**A. INTRODUCTION**

This chapter summarizes and responds to all substantive comments on the Draft Environmental Impact Statement (DEIS), issued on September 5, 2008, for the proposed 363-365 Bond Street project. Oral and written comments were received during a public hearing held by the New York City Planning Commission (CPC) on January 7, 2009. Written comments were accepted from issuance of the DEIS through the public comment period, which ended January 20, 2009.

### **363-365 Bond Street FEIS**

Figure 27-1

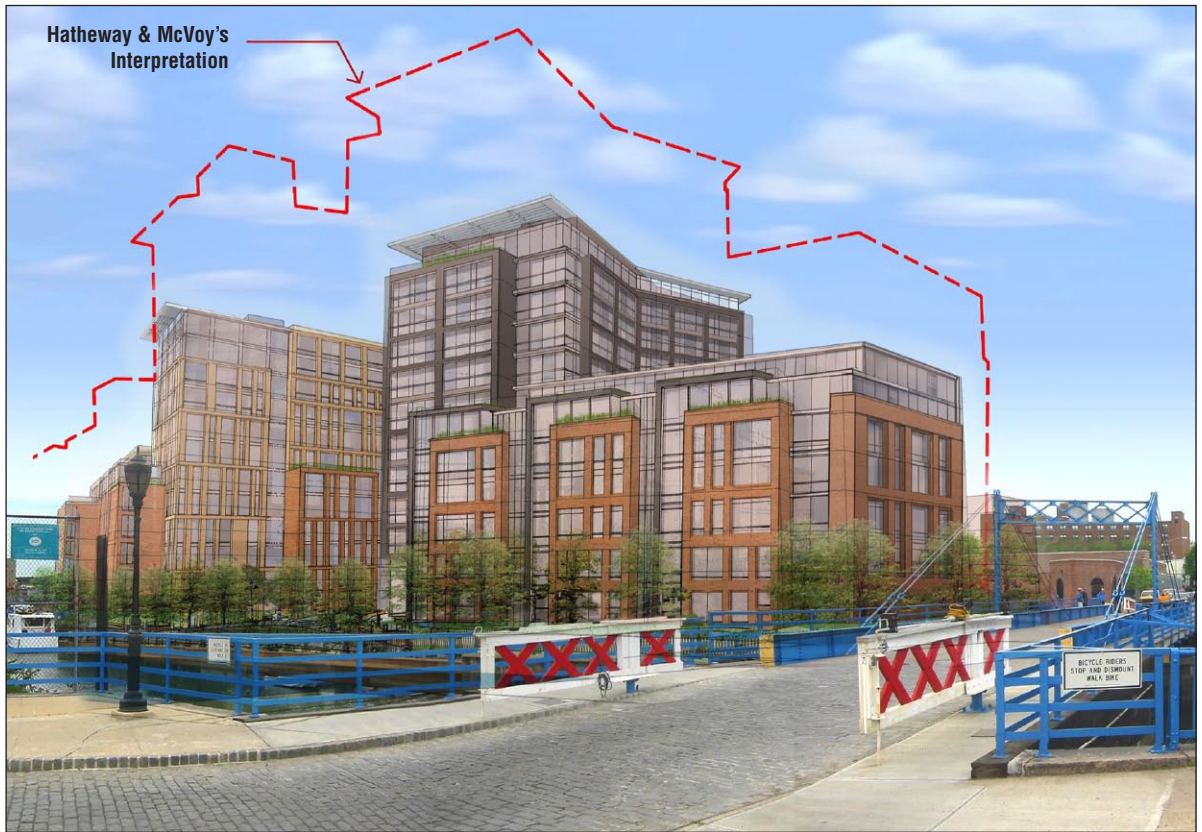
**Comment 1-2:** The rendering from across the canal (Figure 1-11c) inserts the project into the existing photo at a significantly smaller size than it would appear in reality. Measured against the existing buildings in the view, the 12-story portions scale to be approximately 85 feet high instead of the proposed 124 feet and 8 inches and they are shown narrower than they would appear in this view. The rendering also omits the elevator bulkhead which scales to be approximately 145 feet in the section provided in the DEIS. (Hatheway/McVoy)

**Response 1-2:** Figure 1-11c in the DEIS was included for illustrative purposes, and reflects an artist's interpretation of the proposed buildings. The rendering showed general building design, massing, and project layout. The methodology used to develop the commenters' rendering is unclear (see FEIS Appendix I for the submitted written comments on the DEIS). To address the comment, Figure 1-11c has been further refined in the FEIS based on current survey and topographical data. The revised image also accounts for the setback from the water's edge and the 125 foot height limitation. The revised rendering is not significantly different from that which appeared in the DEIS. The DEIS also included measured drawings and accurately scaled site plans showing the heights, including the elevator bulkhead (see Figures 1-5 through 1-10). Based on all these data, it was the conclusion of the DEIS, and remains the conclusion of this FEIS, that the proposed project would not have any adverse impacts with respect to urban design and visual resources.

An additional figure is included to the Response to Comments chapter (see Figure 27-1), which illustrates the inaccuracies of the massing presented by the commenter during the public review process as compared to the massing actually proposed by the applicant. The conclusion of Chapter 8, "Urban Design and Visual Resources," of the DEIS with respect to urban design and visual resources remains unchanged (i.e., no adverse significant impacts from the proposed project).

Proposed with Hatheway & McVoy's Interpretation

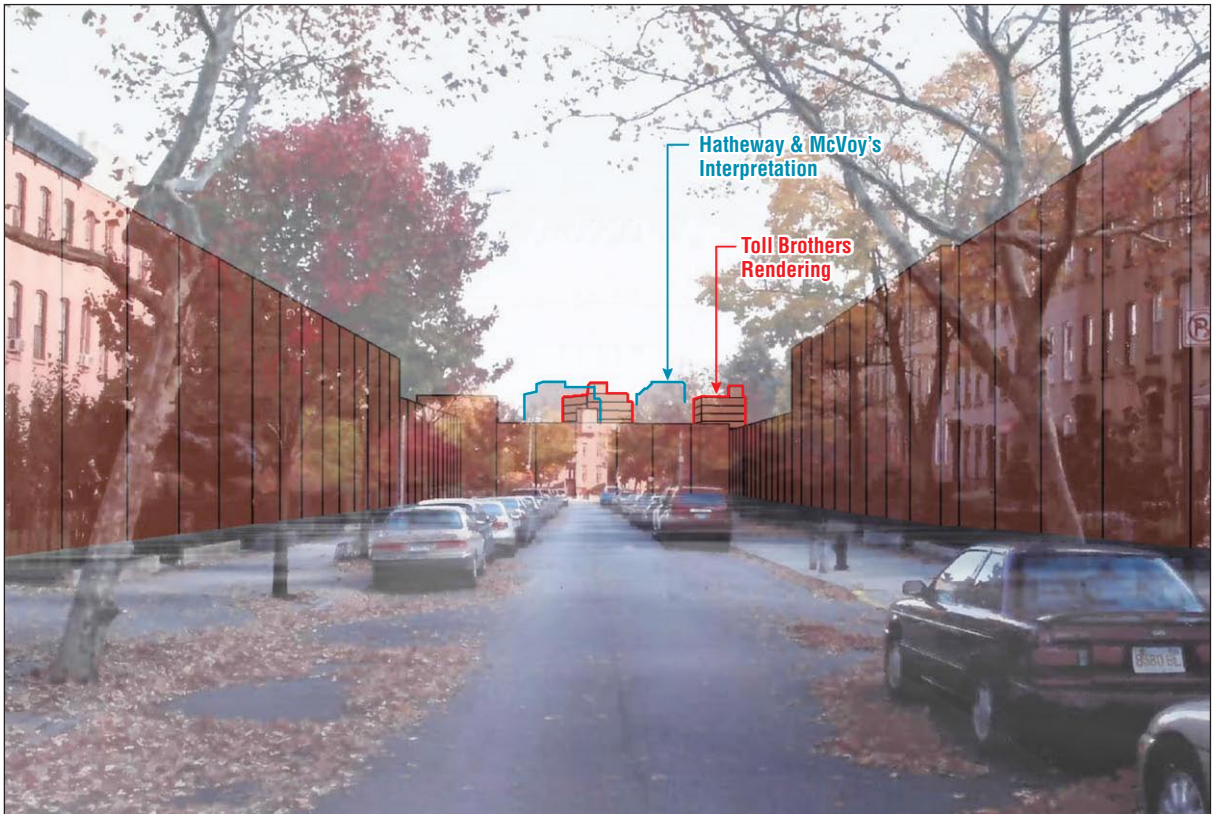
The 400-foot depth of this site is not enough to lessen the impact of a transition from 2- and 3-story buildings to 12-story buildings. (McVoy)

Based on the comment, a graphic has been prepared and added to the FEIS (see Figure 8-17), which depicts the existing conditions and the proposed project's massing from a view down Carroll Street at Smith Street. This figure is based on the current topographic data and the scale and location of the existing (including St. Mary Star of the Sea Residence) and proposed buildings.

An additional figure is included to the Response to Comments chapter (see Figure 27-2), which illustrates the inaccuracies of the massing presented by the commenter during the public review process as compared to the massing actually proposed by the applicant. The conclusion of Chapter 8, "Urban Design and Visual Resources," of the DEIS with respect to urban design and visual resources remains unchanged (i.e., no significant adverse impacts from the proposed project).
